[Docket No. NHTSA–2010–0162]

Rear Visibility; Federal Motor Vehicle Safety Standard, Rearview Mirrors; Federal Motor Vehicle Safety Standard, Low-Speed Vehicles; Phase-in Reporting Requirements

ACTION: Notice of proposed rulemaking; corrections.

Figure 6. Countermeasure Performance Test Area Illustration and Required Test Object Locations

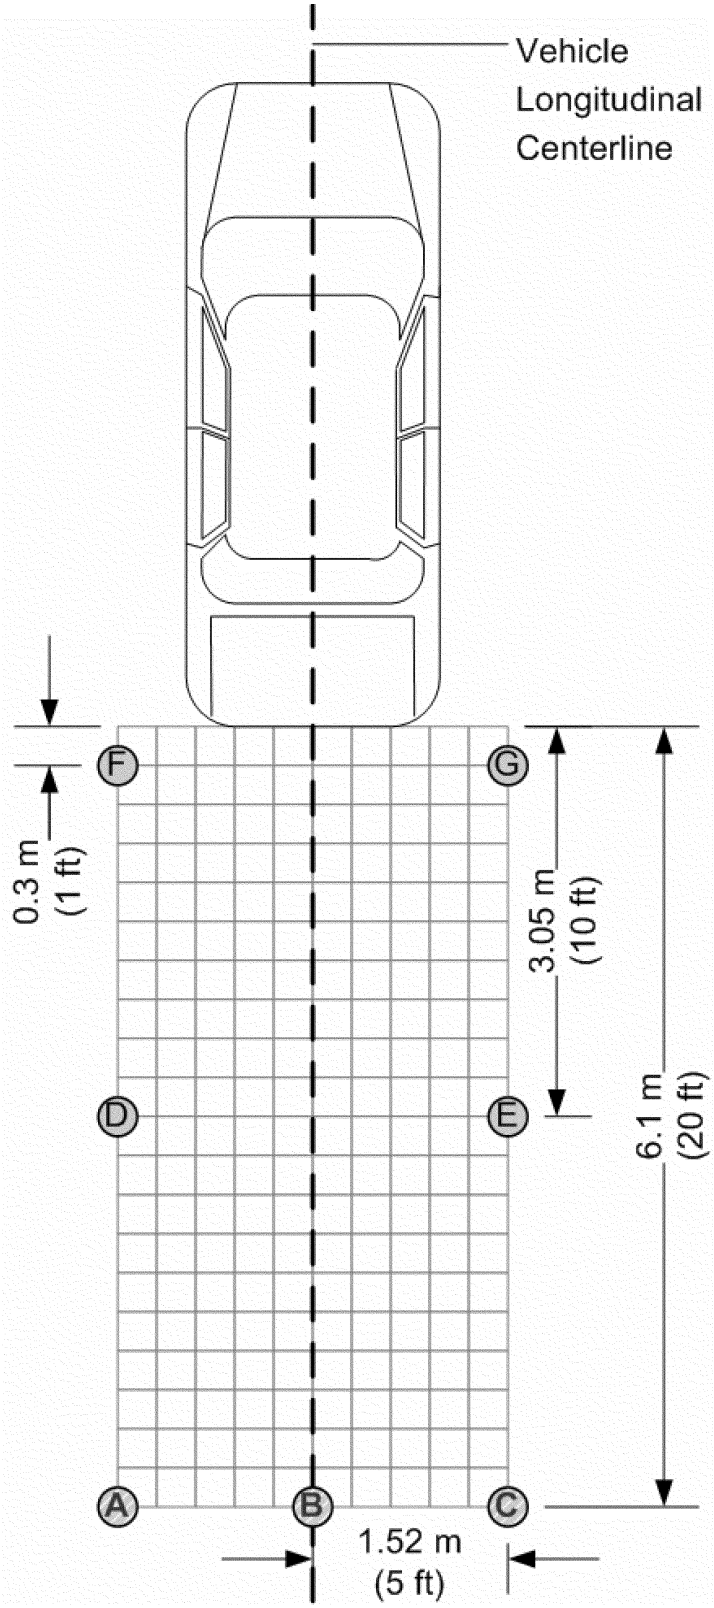
2. On page 76234, figure 6 is corrected to read as follows:

FIGURE 5: TEST CYLINDER LOCATIONS (Units in meters)

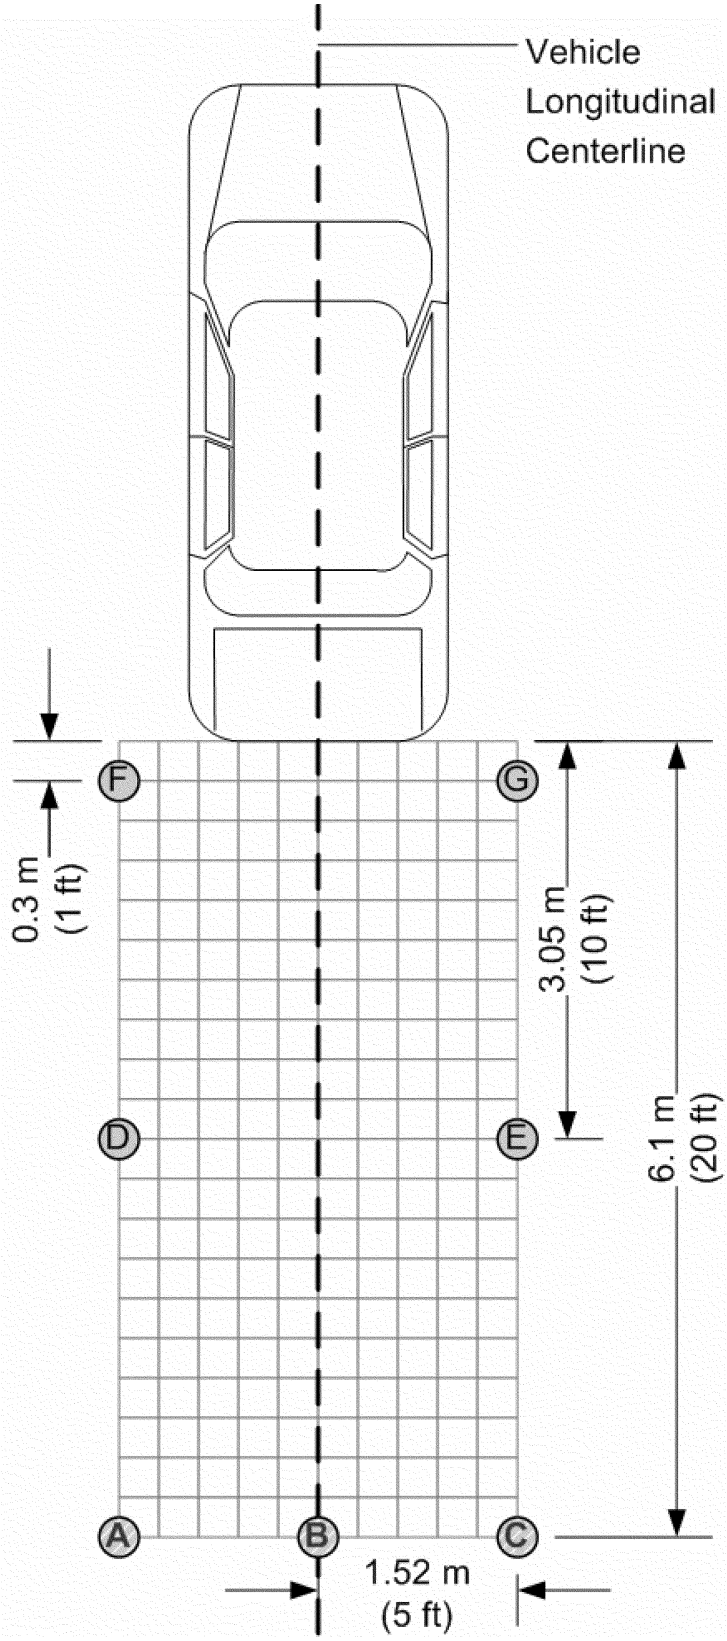
24. On page 76248, Figure 5 is corrected to read as follows:
